# Safety Recall

## N242441392 Right Side Seatbelt Retractor May Lock

**Revision:** 03

**Revision Description:** This bulletin is being revised to update the parts table. Please discard all previous copies of bulletin N242441392.

6682024

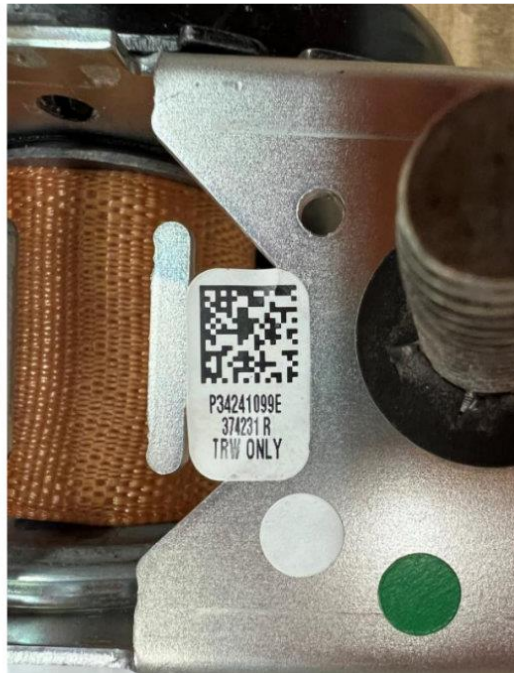
1. Inspect the NEW Seatbelt Retractor label located on the bottom of the Seatbelt Retractor.
  - If the 4<sup>th</sup> and 5<sup>th</sup> digits are “23” AND the 1st and 2nd digits range between “35”-“52”, , The part is BAD and MUST be scrapped. DO NOT INSTALL ON VEHICLE. Reference the Scrap Instructions below. Re-order a replacement Seatbelt Retractor and repeat inspection.
  - If the 4<sup>th</sup> and 5<sup>th</sup> digits are “23” AND the 1st and 2nd digits DO NOT range between “35”-“52” proceed to Step 3.
  - If the 4<sup>th</sup> and 5<sup>th</sup> digits are “24”, Proceed to Step 2.

6682025

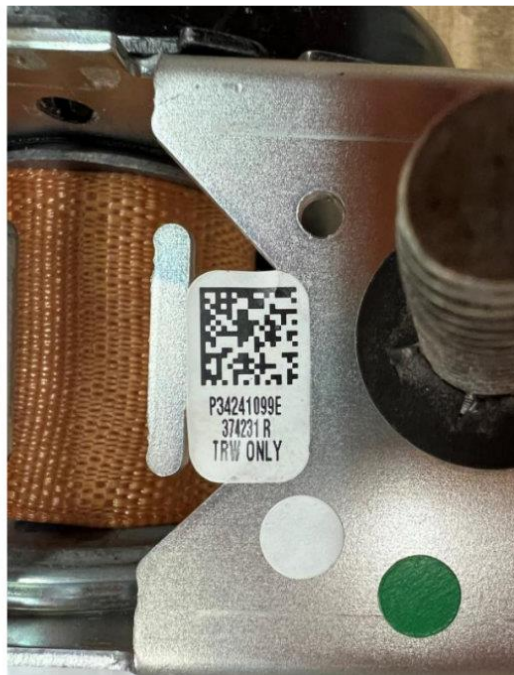
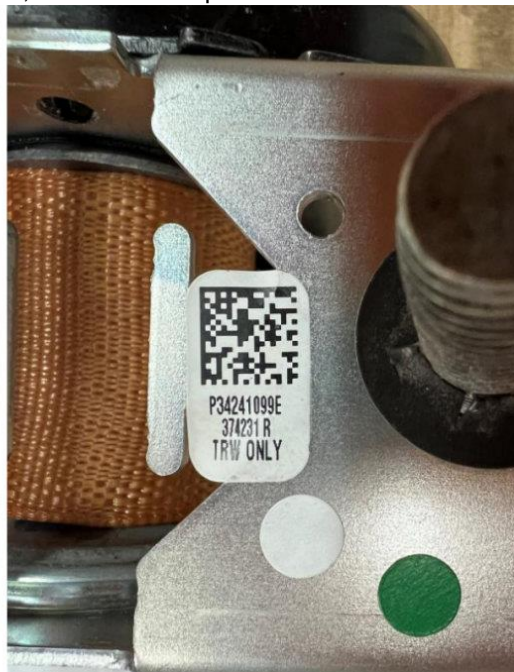
2. Continue to inspect the NEW Seatbelt Retractor label located on the bottom of them retractor.
  - If the 4th and 5th digits are “24” AND the 1st and 2nd digits are “01”, “”, The part is BAD and MUST be scrapped. DO NOT INSTALL ON VEHICLE. Reference the Scrap Instructions below. Re-order a replacement Seatbelt Retractor and repeat inspection.
  - If the 4th and 5th digits are “24” AND the 1st and 2nd digits are NOT “01” proceed to Step 3.
3. Replace the RH Front Seat Belt Retractor. Refer to *Front Seat Belt Retractor Replacement* in SI. If convertible, refer to *Front Seat Belt Retractor Replacement - Right Side (Convertible)* in SI.
4. Scrap all replacement Seat Belt Retractors that failed inspection steps 1 and/or 2 AND the used Seatbelt Retractor. Refer to the Scrap instructions below.
